**STAFF REPORT TO THE BOARD OF ARCHITECTURAL REVIEW  
DESIGN REVIEW – PUBLIC HEARING  
Prepared October 2, 2018**

**PROJECT NUMBER:** PL18-0008

**FILE NUMBER:** L18-0012 Design Review – Public Hearing

**REQUEST:** Design Review approval is requested for construction of a two-story, 14,700 sf structure and associated parking within the shoreline environment.

**Figure 3: Site plan showing vehicular and pedestrian access from Interurban Ave S and Fort Dent Way**

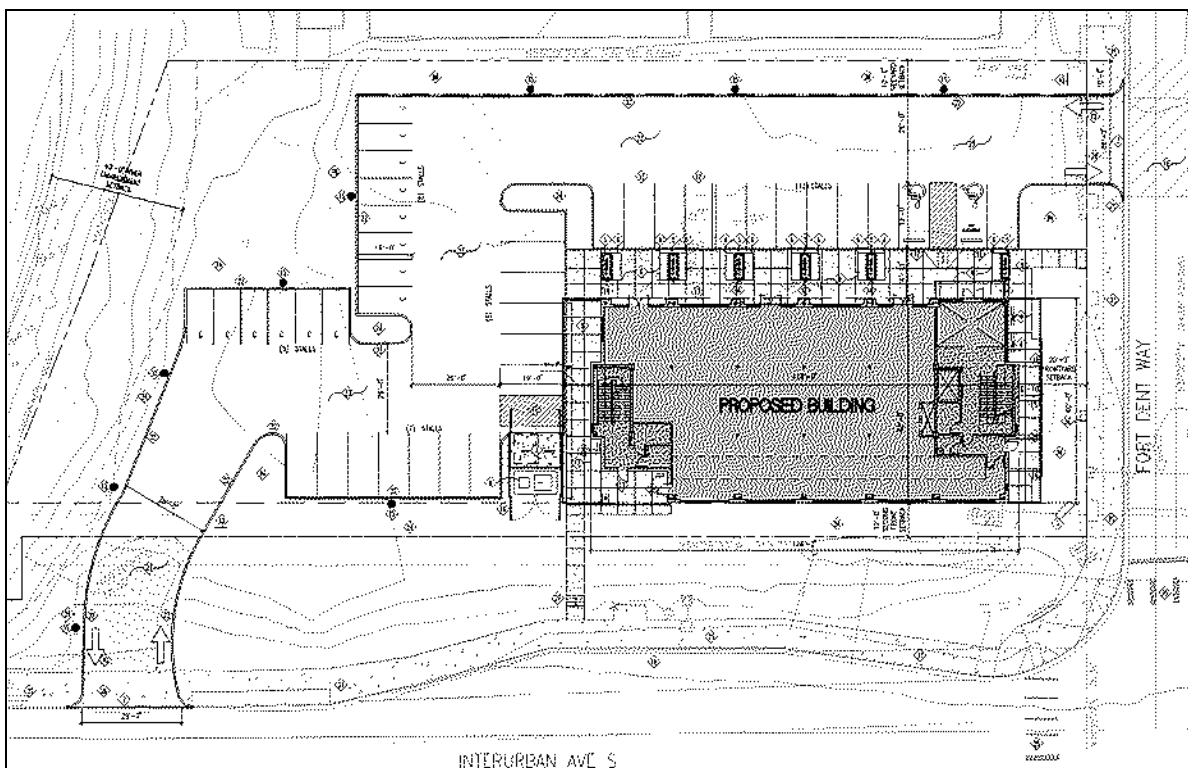
The structure's main entrance and parking area are located along the northern elevation of the structure, providing a safe staging area away from the intersection of Interurban Ave S and Fort Dent Way. A pedestrian pathway is provided from Fort Dent Way as well as Interurban Ave S, providing easy access to and from the King County Metro bus stop along Interurban Ave S.

A paved pedestrian pathway from Interurban Ave S to the main entrance has been provided. Entrance and exit ramps are located away from the building at each end of the parking area, reducing potential conflicts with pedestrians.

Figure 4: Proposed Exterior Lighting

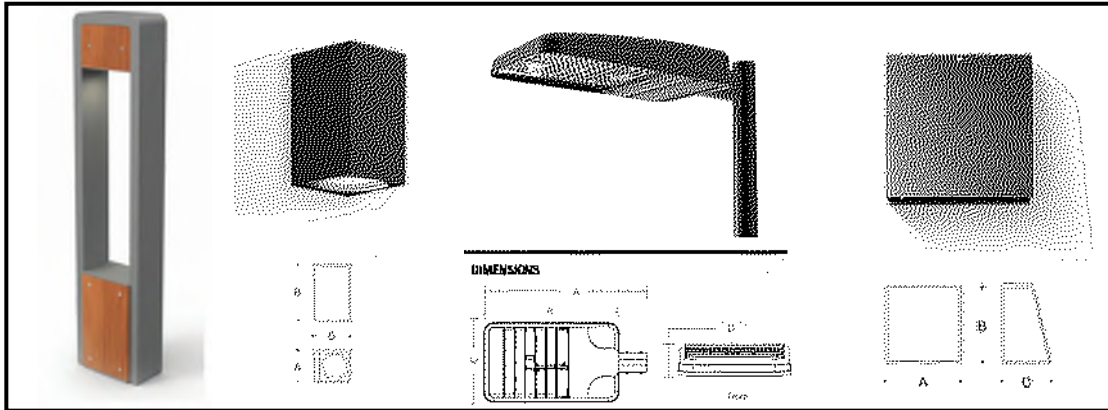
Exterior lighting is harmonious with contemporary design of main structure (see Figure 4).

Figure 5: North Elevation showing windowed atrium at southeast corner of structure.

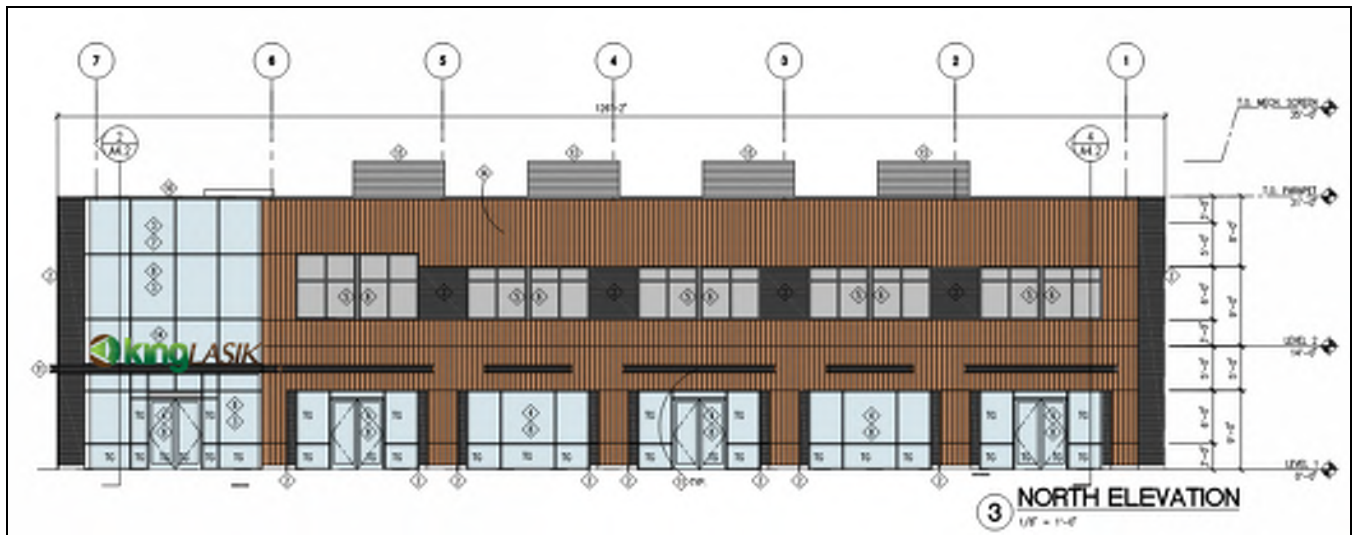
A large windowed atrium containing the main entrance and stairwell at the southeast corner of the structure provides variation in form along the north and east elevations. Floor-to-ceiling windows along the ground floor provide additional visual interest and reduce the impact of sections of blank walls.
